Project	IEEE 802.16 Broadband Wireless Access Working Group < http://ieee802.org/16 >	
Title	Update of network entry figures	
Date Submitted	2005-07-06	
Source(s)	Giulio Cavalli Siemens	Voice: +39 0224376380 Fax: +39 0224376726 Giulio.cavalli@siemens.com
Re:	Corrigendum Sponsor Ballot	
Abstract	Editorial modifications to network entry figures to reflect security support	
Purpose	To incorporate the text changes proposed in this contribution into the P802.16_Cor1/D3 draft	
Notice	This document has been prepared to assist IEEE 802.16. It is offered as a basis for discussion and is not binding on the contributing individual(s) or organization(s). The material in this document is subject to change in form and content after further study. The contributor(s) reserve(s) the right to add, amend or withdraw material contained herein.	
Release	The contributor grants a free, irrevocable license to the IEEE to incorporate material contained in this contribution, and any modifications thereof, in the creation of an IEEE Standards publication; to copyright in the IEEE's name any IEEE Standards publication even though it may include portions of this contribution; and at the IEEE's sole discretion

Figure 66 – Wait for SBC-RSP- SS

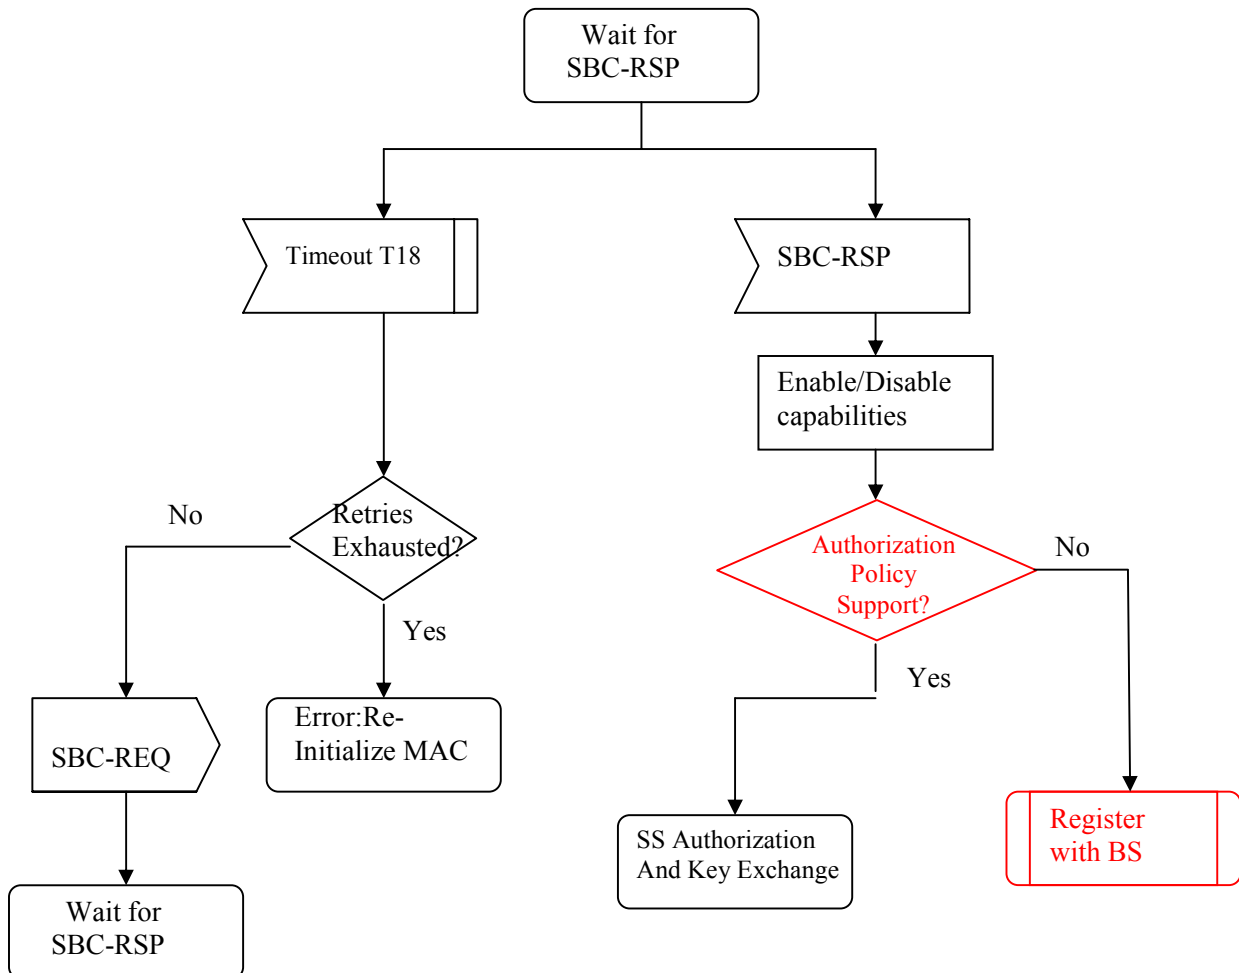
In order to make the document consistent, the figure 66 and figure 70 shall be updated according to changes in paragraph 6.3.9.8 where it is stated that "If PKM is enabled the BS and SS shall perform authorization and key exchange". Authorization policy can be supported or not supported by the SS and the network entry procedure should reflect this option.

[paragraph 6.3.9.7, replace Figure 66 with the following figure]

Figure 70 – Registration- BS

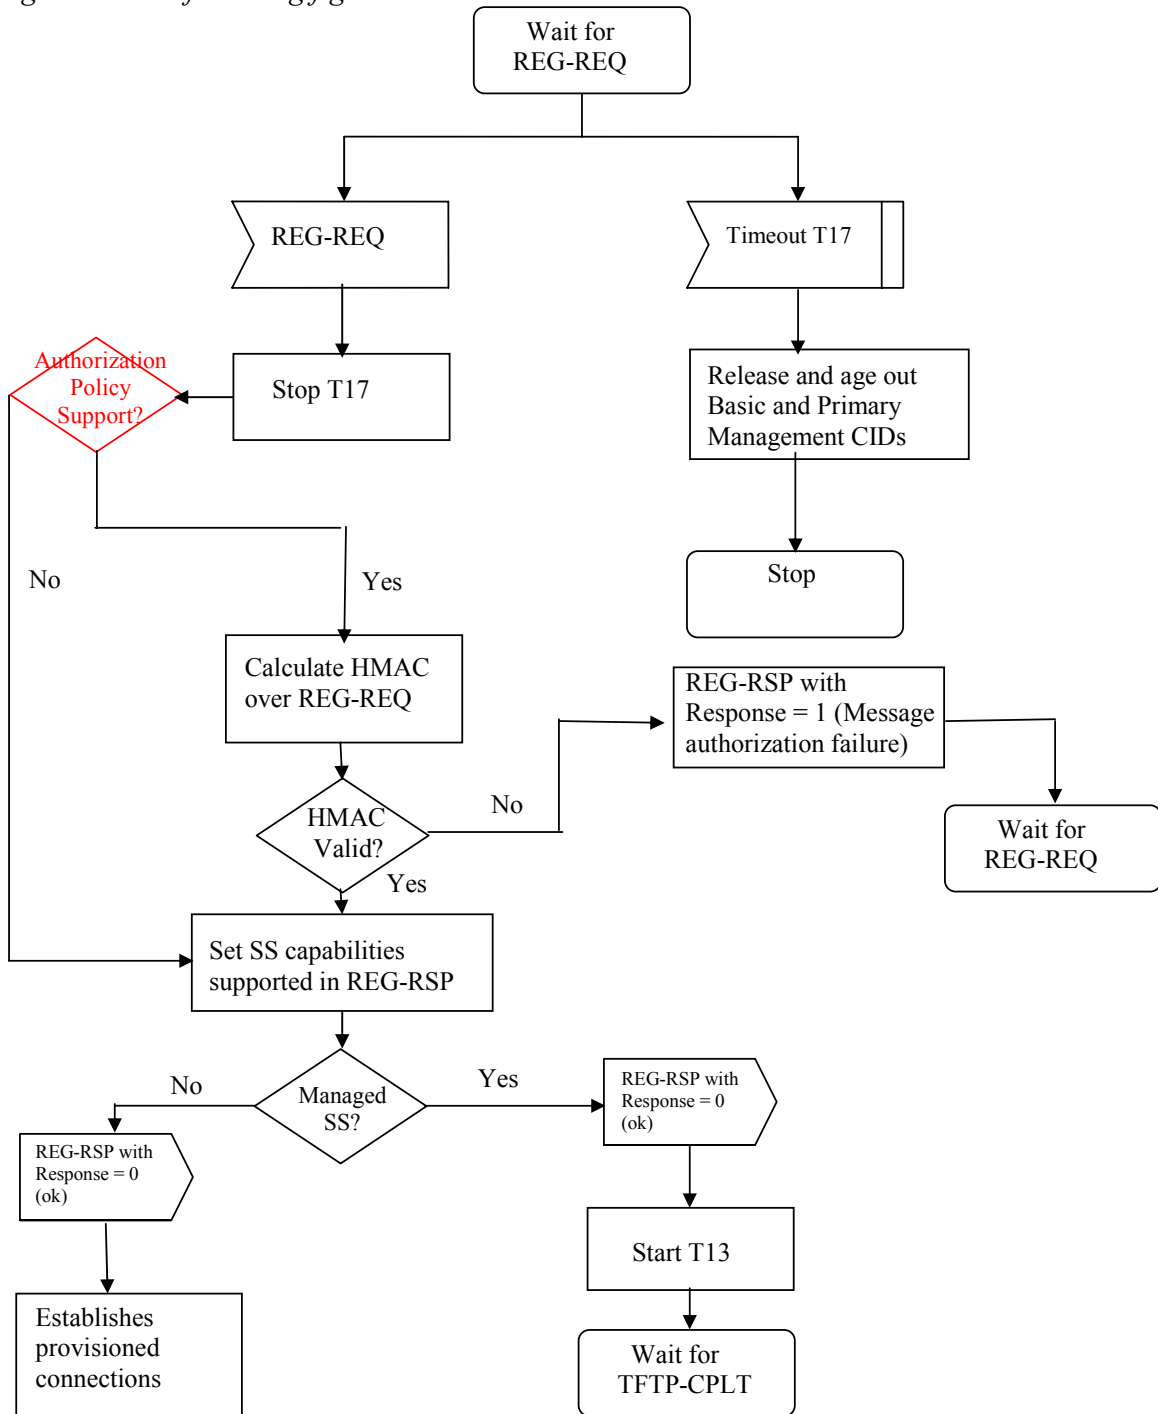
Replace Figure 70 with following figure
